**SPECIFIC AGENDA WORDING: Consideration of Halff Engineering Flood Study Review No. 1, 2, and 3 and approval of road cut to be made in accord with such study to accommodate box culverts and drainage under County Road 805 from Villages of Mayfield Phase I in City of Cleburne in Johnson County, Texas.**

**Re: Villages of Mayfield Phase 1 – Flood Study Review #1**

**Re: Villages of Mayfield Phase 1 – Flood Study Review #2**

**Re: Villages of Mayfield Phase 1 – Flood Study Review #3**

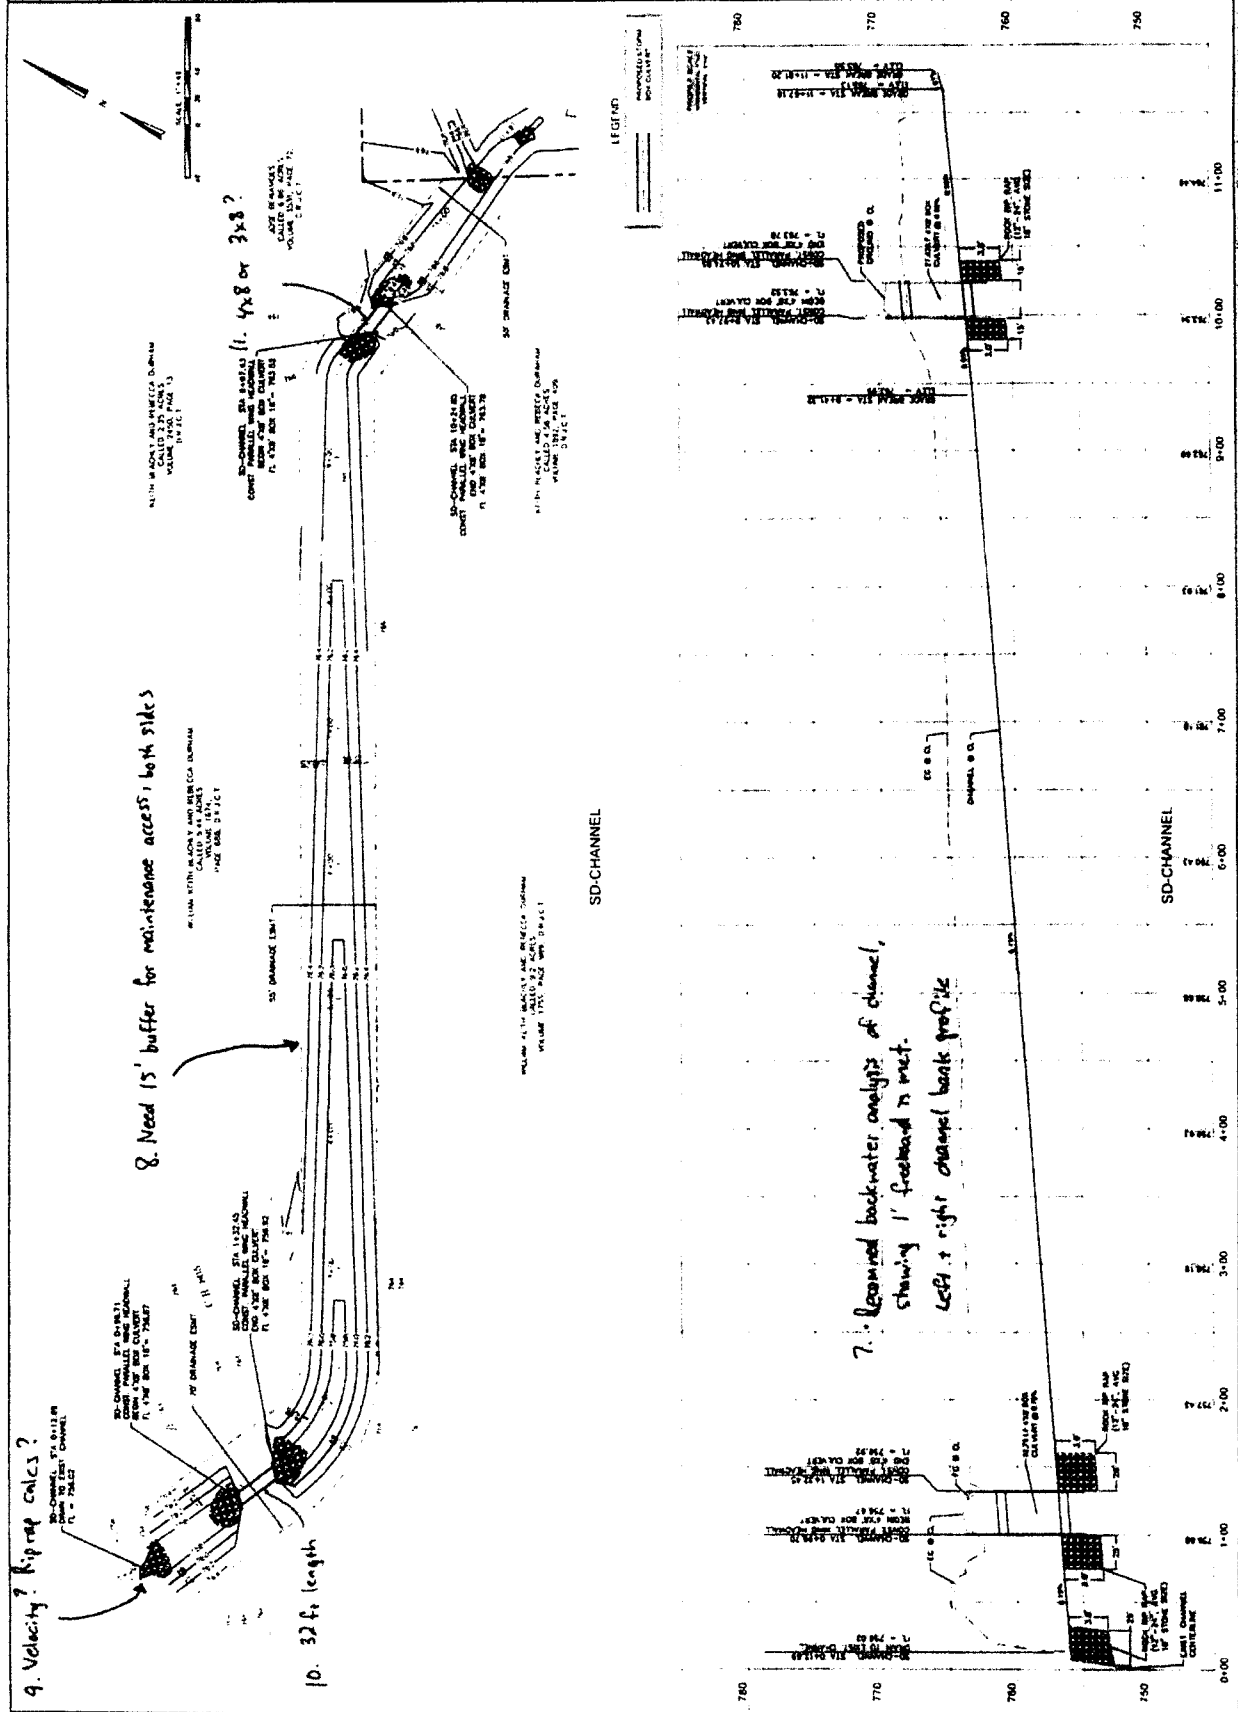
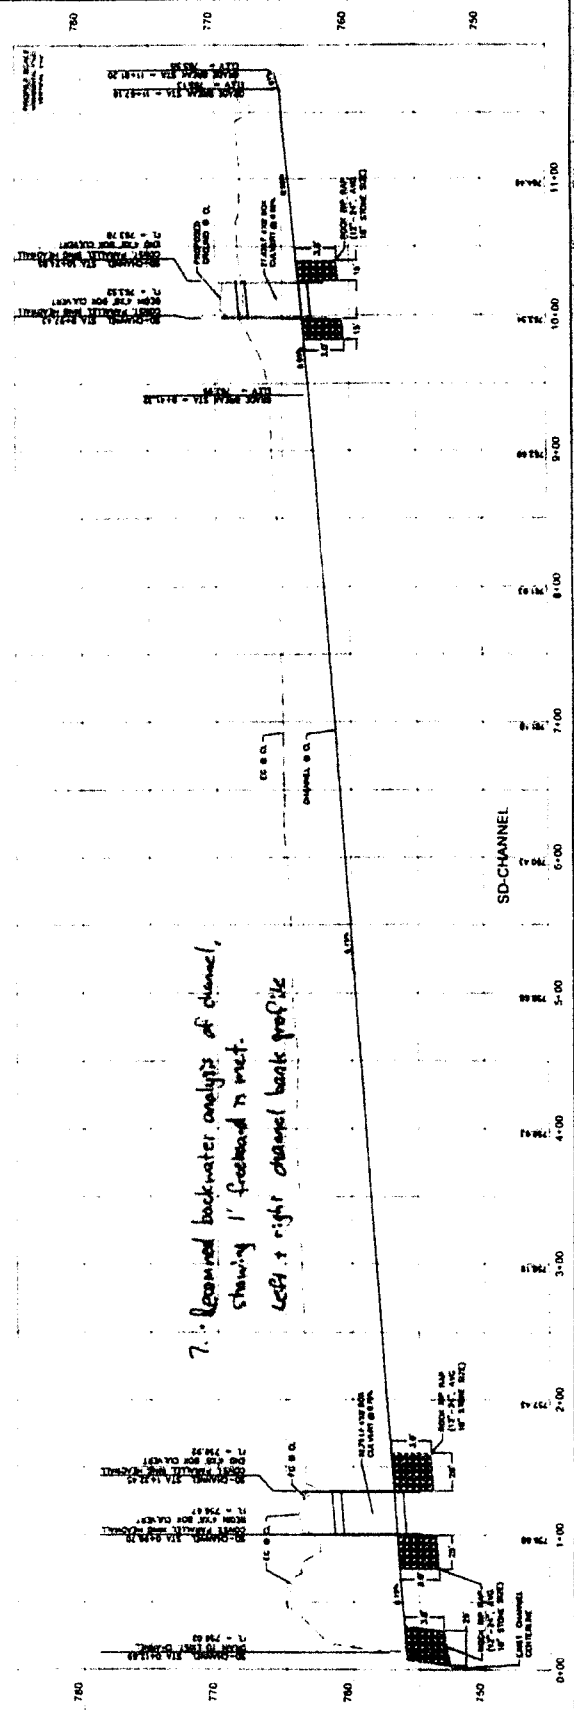
9. Velocity? Pipe cap coils?

8. Need 15' buffer for maintenance access, both sides

10. 32 ft. length

7. Examined backwater analysis of channel, showing 1' freboard in inst. Left + right channel bank profile

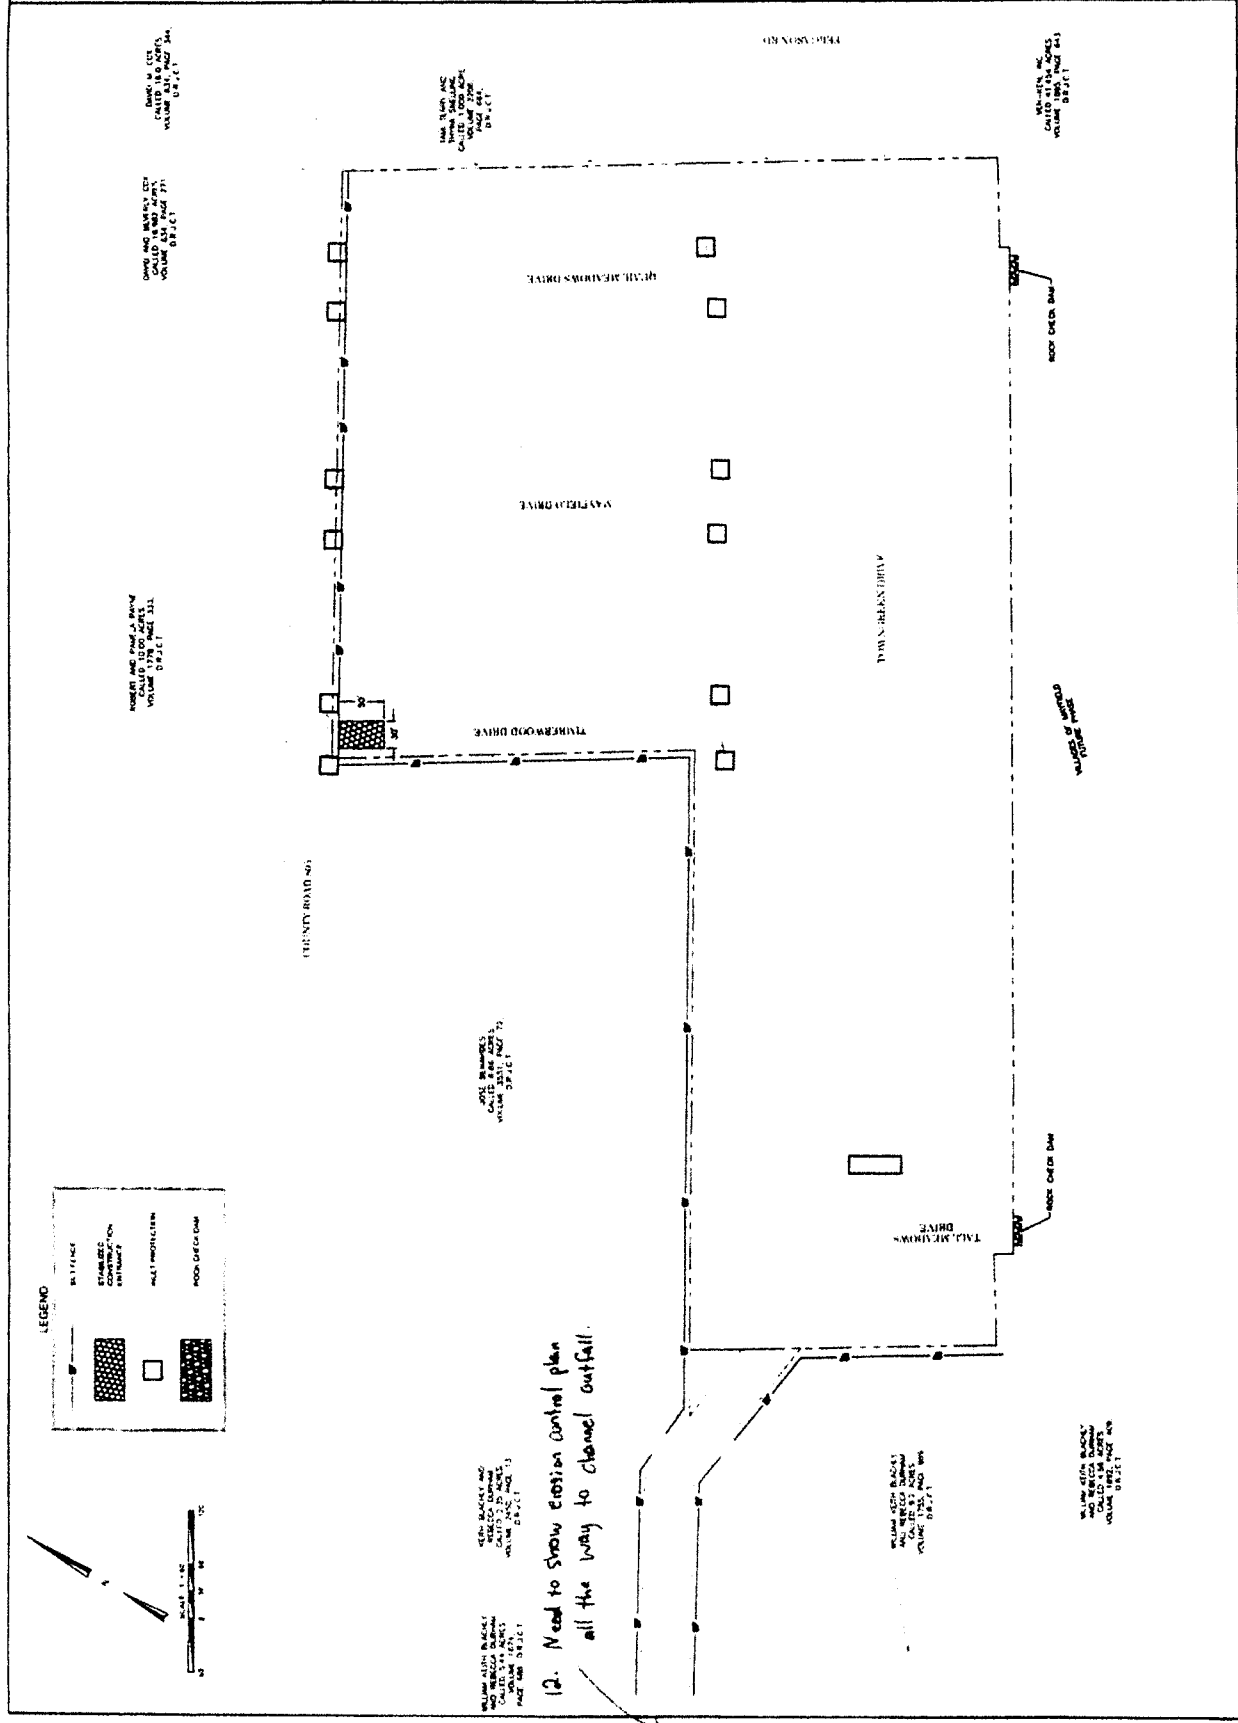
12. Need to show erosion control plan  
 all the way to channel outfall.

C4.1

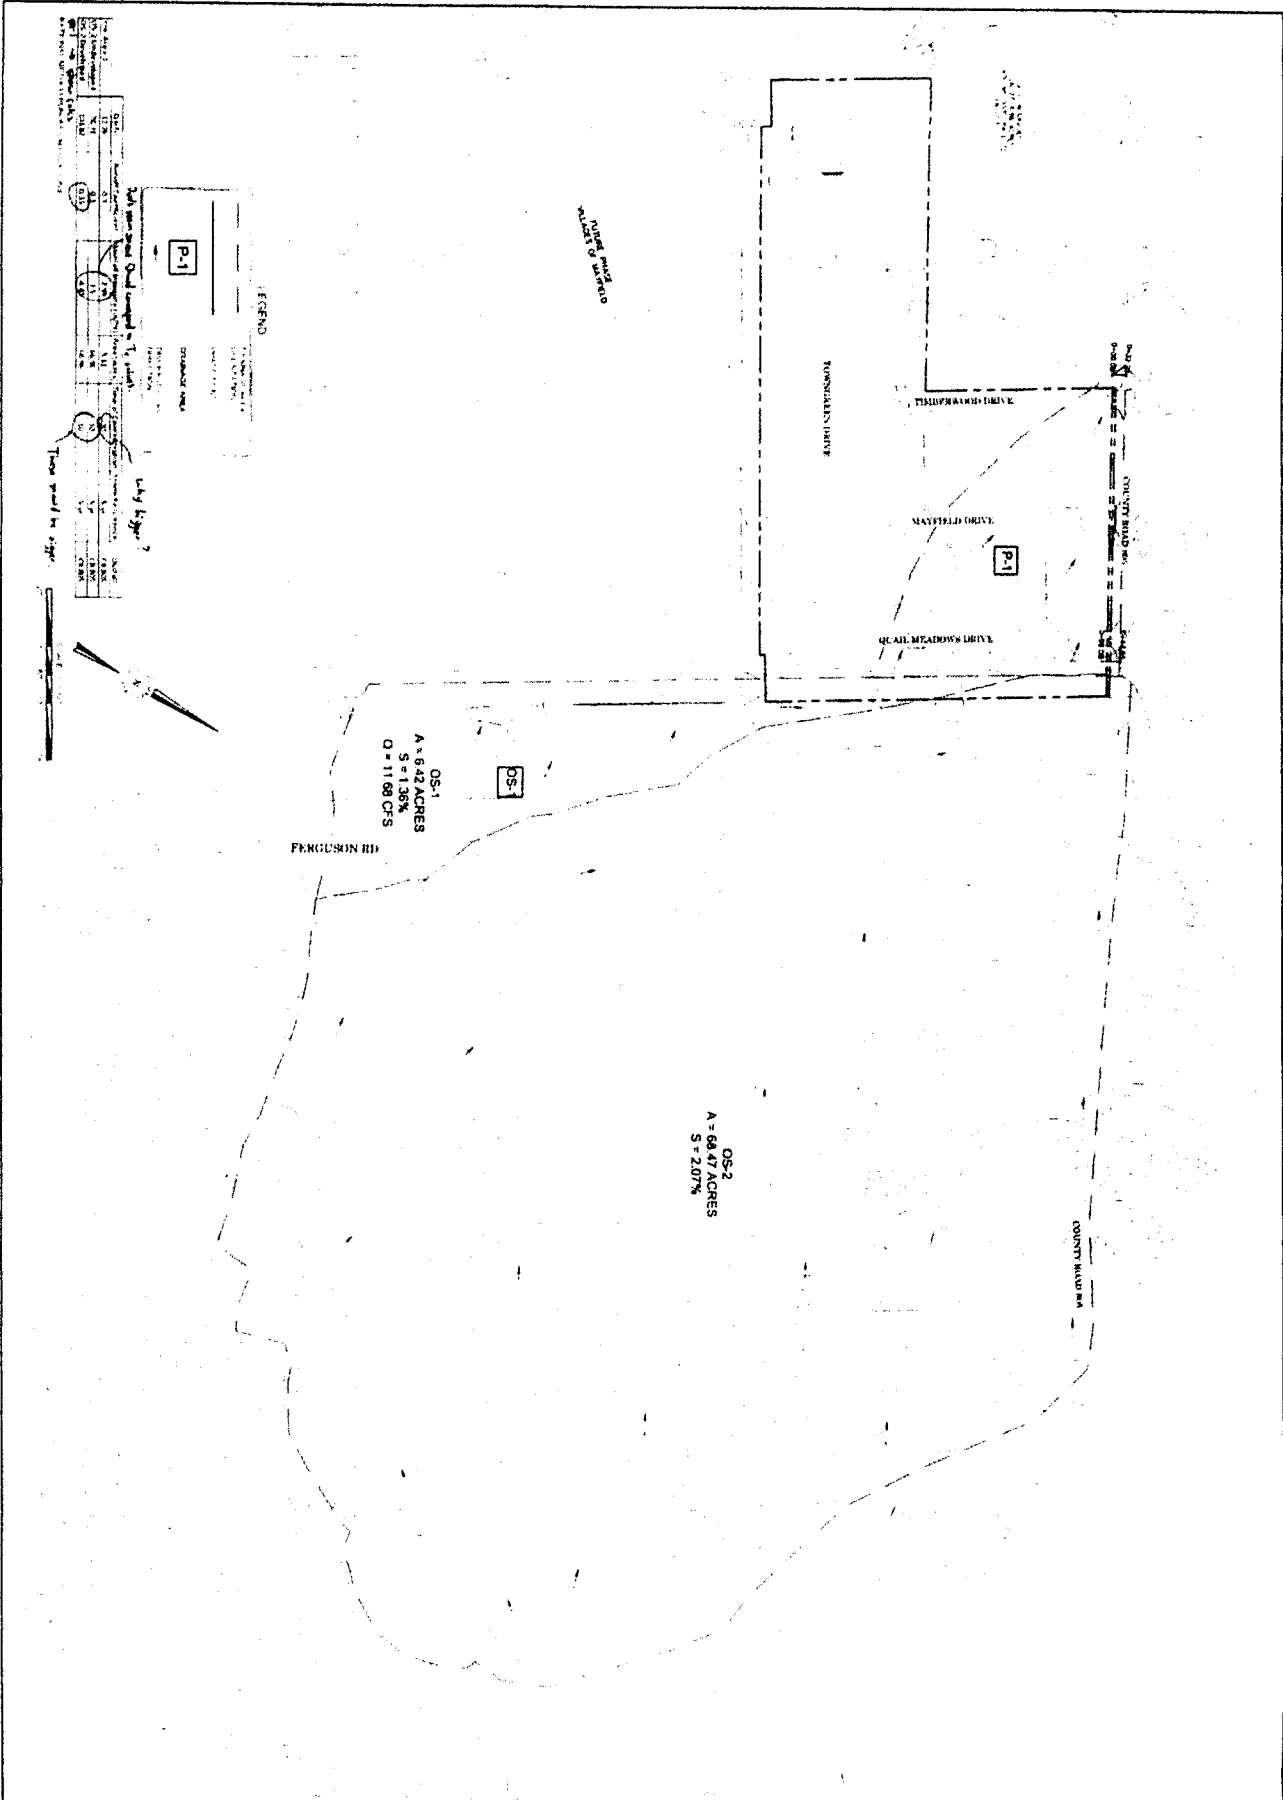
14. Sheet C-4.1: OS-1 runoff calculations not shown in the table. Please add.
15. Sheet C-4.1: Why are intensities for OS-2 different for developed and undeveloped conditions when the time of concentration and storm recurrence are the same? Also, the time of concentration for larger area OS-2 is 10 minutes, whereas the smaller P-1 is 20 minutes. Please clarify or revise.
16. Please note that the minimum time of concentration for residential areas is 15 minutes per SSRJCO Appendix A, D.1.b. Since the value of 10 minutes used is conservative, no action is required. However, if the drainage design components are modified as a result of this comment, please respond with what has changed.

C-4.2

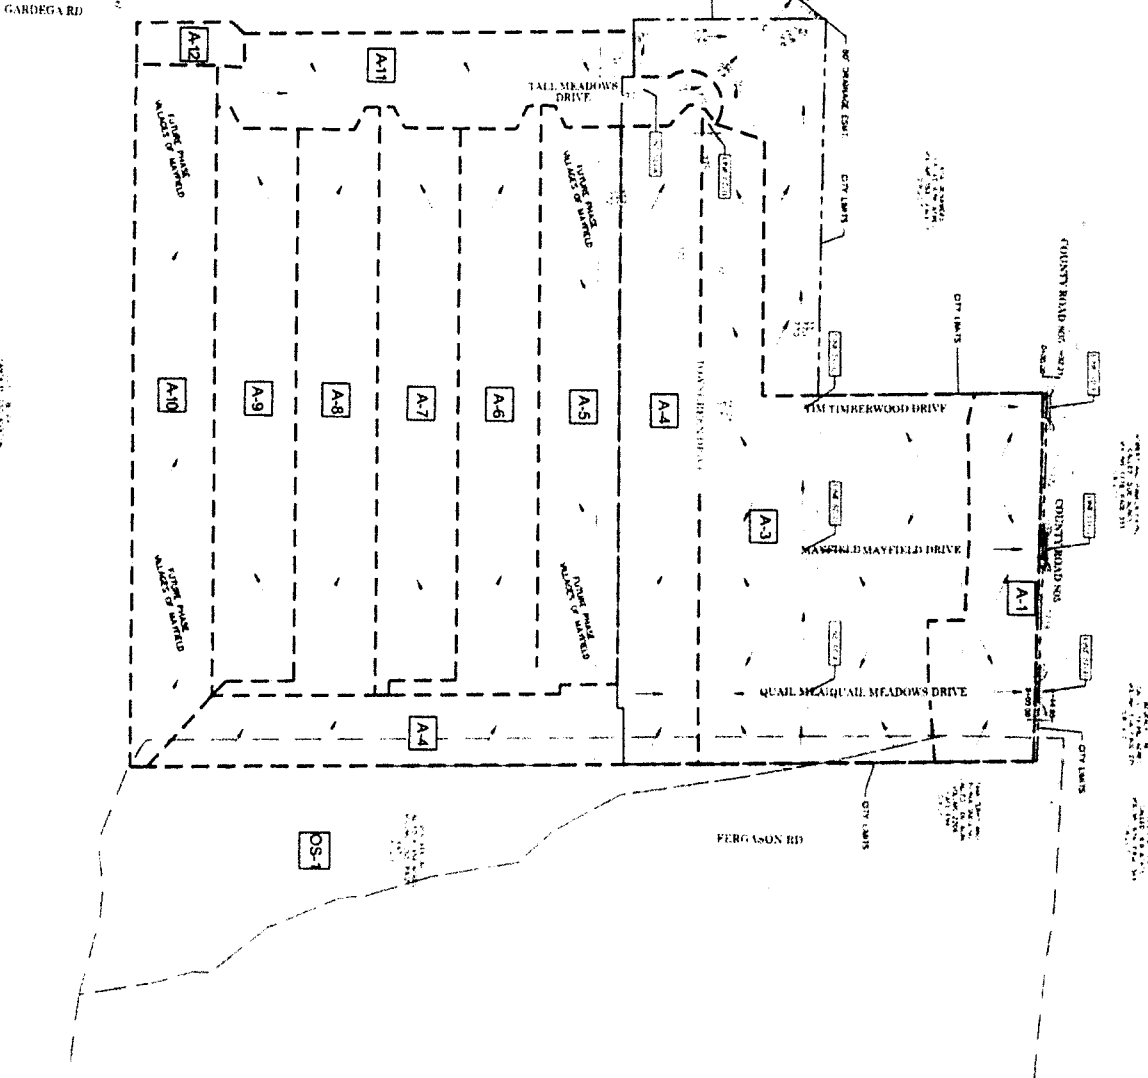
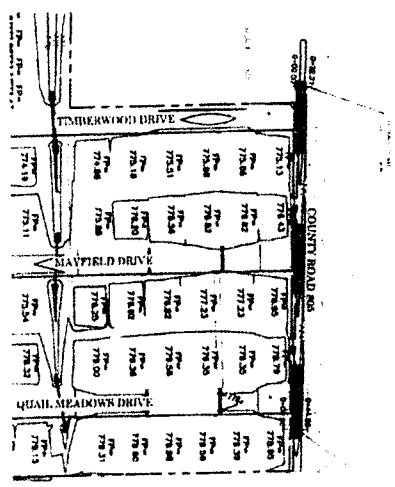
*Should include proposed new 4:1 slope of ditches to bridge.*

*Adjacent to property?*
